FINAL REPORT

ARIZONA CANAL DIVERSION CHANNEL AESTHETICS COMMITTEE

MAY 5, 1989

RE: Transmittal of ACDC Aesthetics Committee Final Report
for Review and Comment

**Figure 13. REACH 3: CAVE CREEK WASH/REACH 3
BOUNDARY TO HATCHER ROAD (SUBREACH 10)**

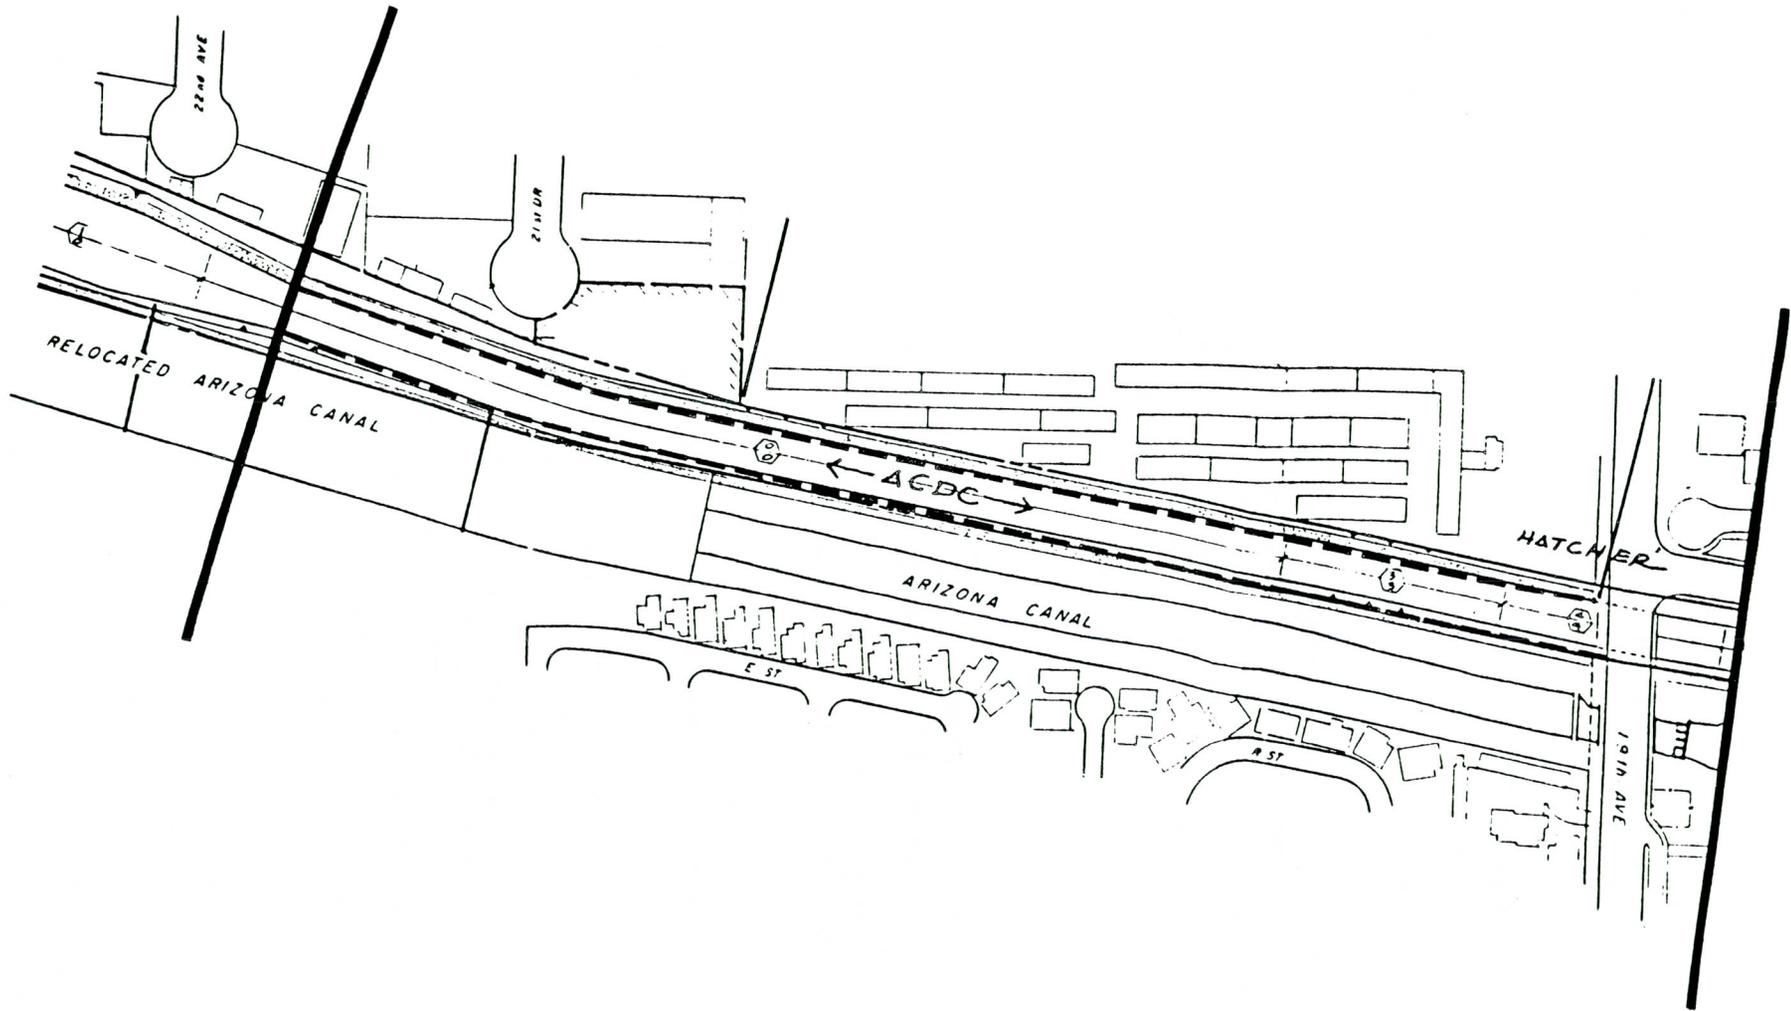
1. Trails should meet AASHTO and other accepted standards for design of bicycle, equestrian, handicapped-use facilities.
2. Explore the possibility of eliminating the north-side maintenance road in this subreach to allow room for additional landscape screening and/or of realigning the ACDC trail in cooperation with Salt River Project to provide space for additional plantings between the south bank of the Channel and the trail.

Figure 14. REACH 3: HATCHER ROAD TO DUNLAP AVE. (SUBREACH 9)

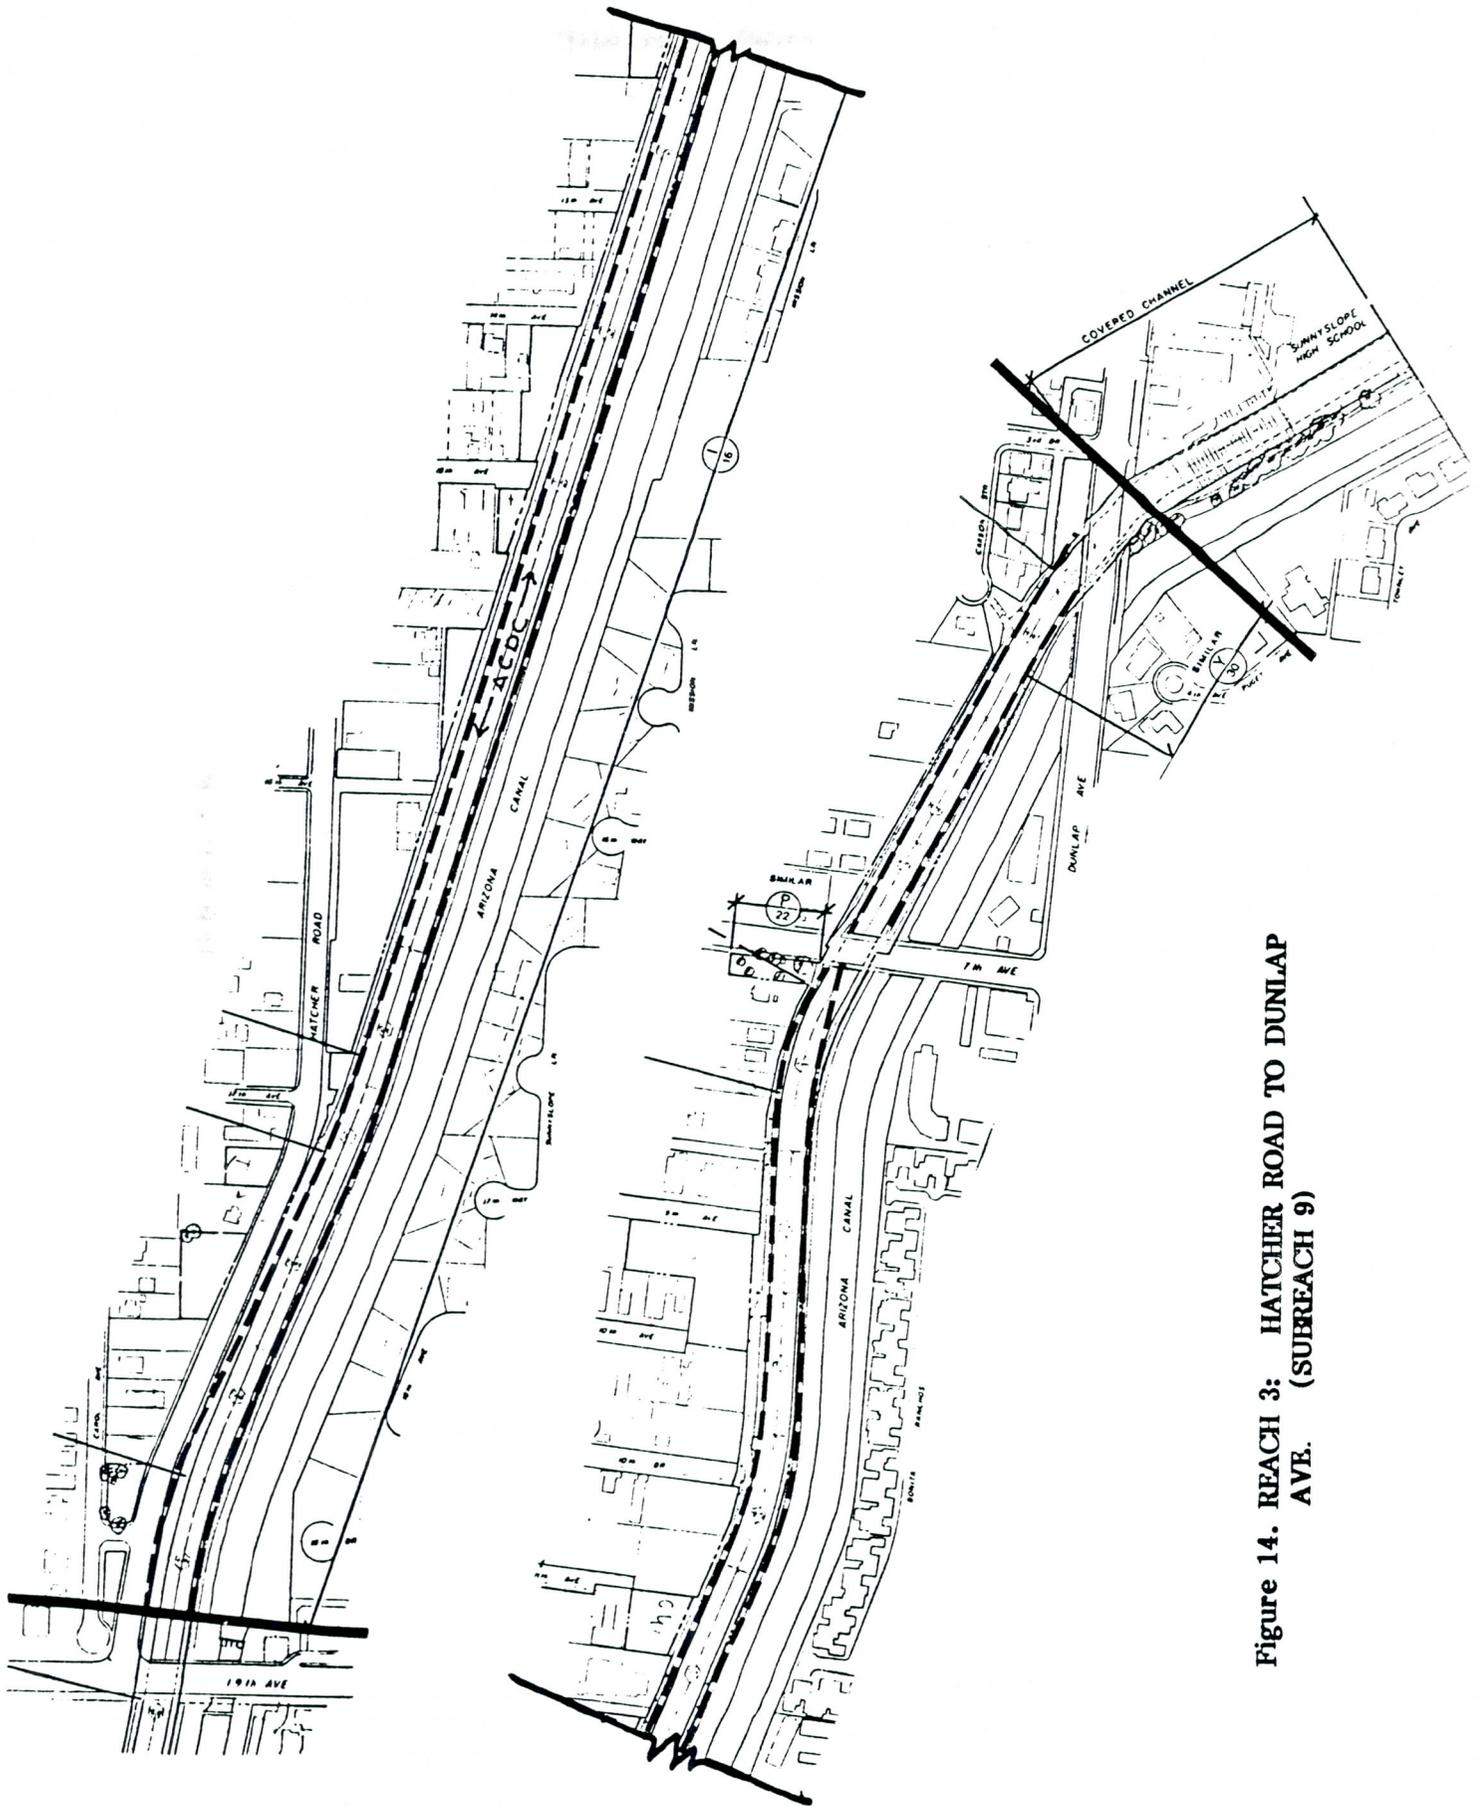
1. Inventory all existing, mature trees along the ACDC within this subreach that may not yet have been removed for construction. Box and relocate or replace these trees. Where mature trees were previously removed due to ACDC construction, add mature, specimen-quality trees of similar varieties to landscaping plans for the area.
2. Provide upgraded landscaping along the ACDC, including the south bank of the Channel, and along the Arizona Canal to screen "eyesore" uses and provide amenity and character.
3. Work with the Phoenix Arts Commission, Village Planning Committee and other groups to identify and design "gateway" or other theme landscape treatments at the 7th Avenue/Dunlap area of ACDC.
4. Incorporate use of theme trees identified as part of

Figure 15. REACH 3: DUNLAP ROAD TO CENTRAL AVENUE (SUBREACH 8)

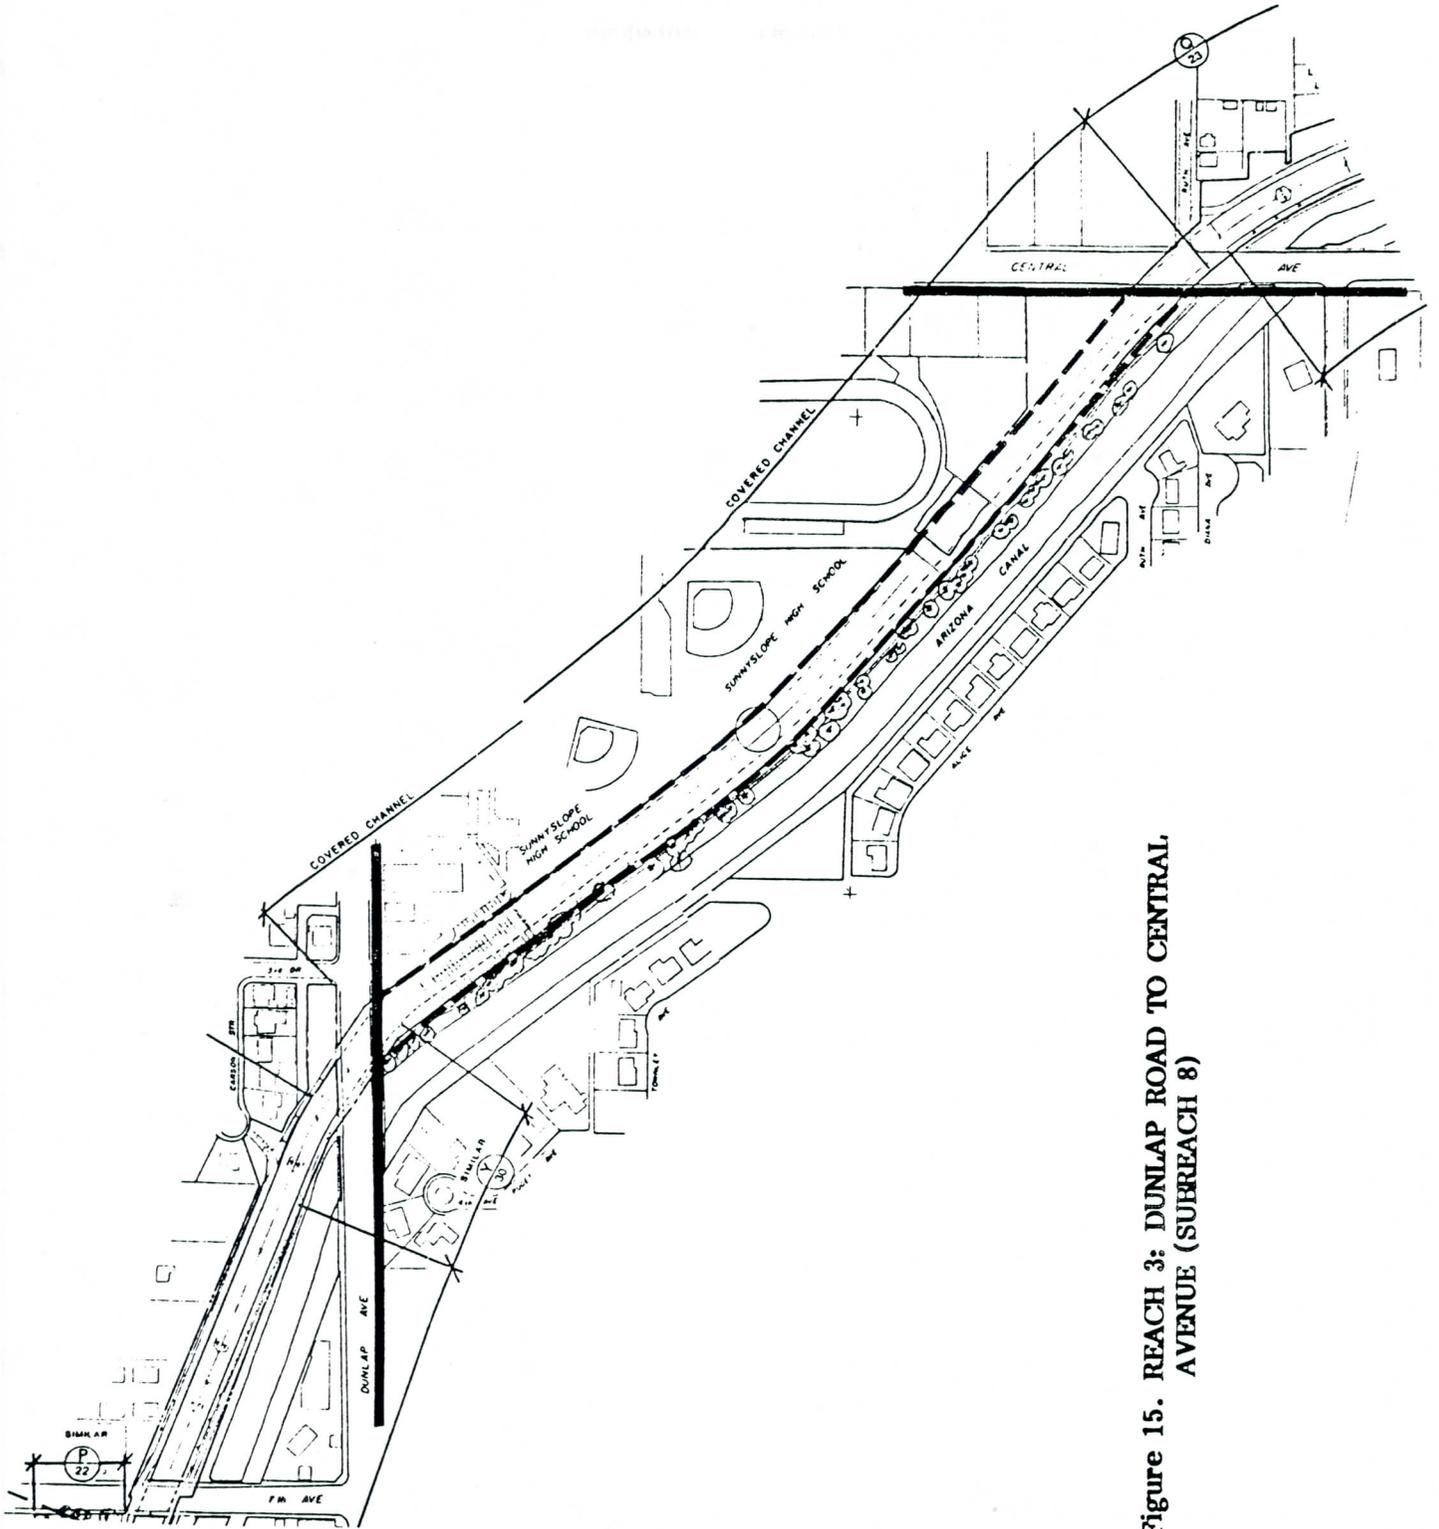
1. Provide lighting for the ACDC trail in this subreach.
2. Review trail plans for conformance to design standards for all user groups and make any changes needed to bring the trails into conformance.

Figure 16. REACH 3: CENTRAL AVENUE TO DREAMY DRAW/EAST BOUNDARY OF REACH 3 (SUBREACH 7)

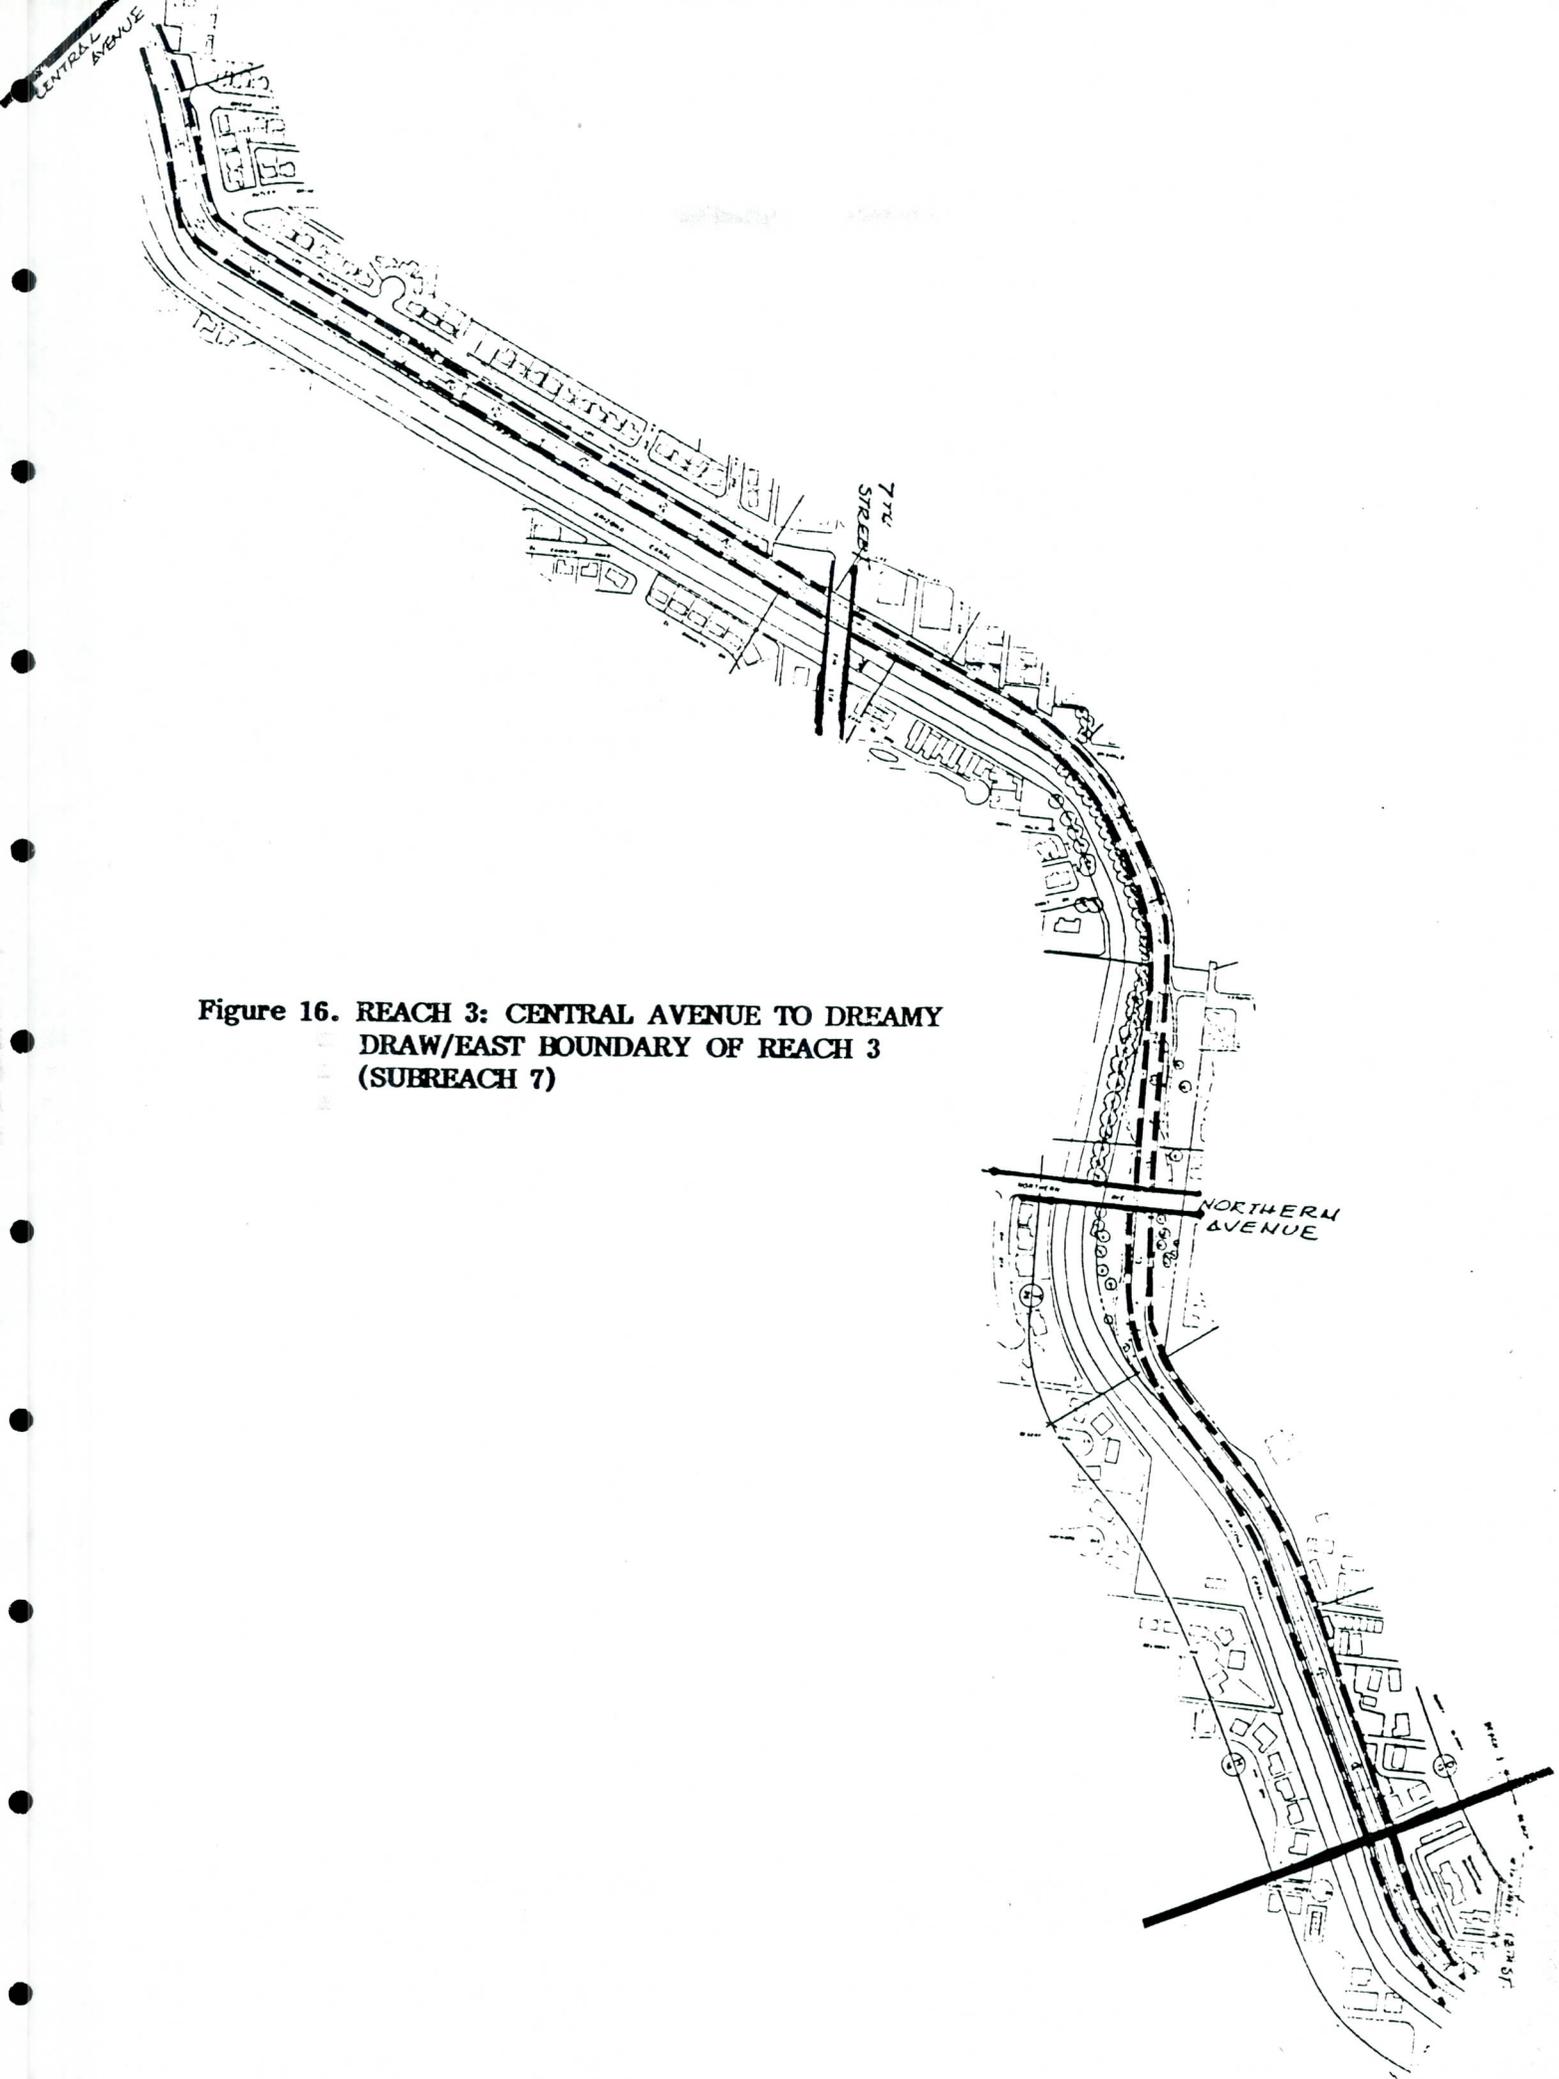
1. Provide increased/intensified landscaping in this subreach, appropriate to surrounding residential areas.
2. Include plant materials that relate to established neighborhood landscape character or to theme plantings adopted as part of the Specific Plan process for this area.
3. Where homes face the ACDC, provide an improved visual barrier wall and associated landscaping, taking into account comments and recommendations for Subreach 13.
4. Prepare plans for "gateways" or other distinctive aesthetic treatments at Northern, 7th Street and Central

5. Add landscaping along south bank of ACDC, between the trail and the Channel. Explore possible realignment of the trail in cooperation with Salt River Project if necessary to accomplish this.
6. Where mesquite, palms and other mature trees are removed to allow construction of ACDC, it is strongly recommended that specimen trees of similar varieties be installed, of sizes as close to those of the trees removed as possible.
7. Take steps to protect the privacy and security of homes along the ACDC through barrier fencing or landscaping (see Figure 7, following p. 57).
8. Provide parking for trail users within the staging area planned at Northern Avenue, to discourage parking on neighborhood streets and private property in the area.
